Motorola Semiconductor Technical Data

Addendum to MC68HC812A4 Advance Information

This addendum provides a correction to the *MC68HC812A4 Advance Information, Motorola document order number MC68HC812A4/D*.

Figure 11-3. Expanded Wide Mode FLASH EEPROM Expansion Schematic (Sheet 2 of 3)

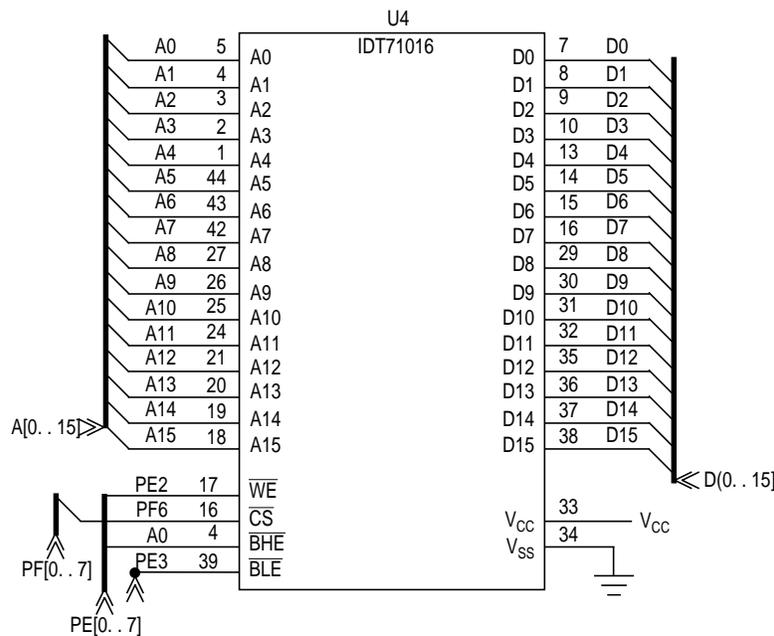
- Page 39 — Change information in **Figure 11-3. Expanded Wide Mode FLASH EEPROM Expansion Schematic (Sheet 2 of 3)**. Signal names on pins 4 and 39 were swapped. Pin 4 is now A0 and pin 39 is now PE3.
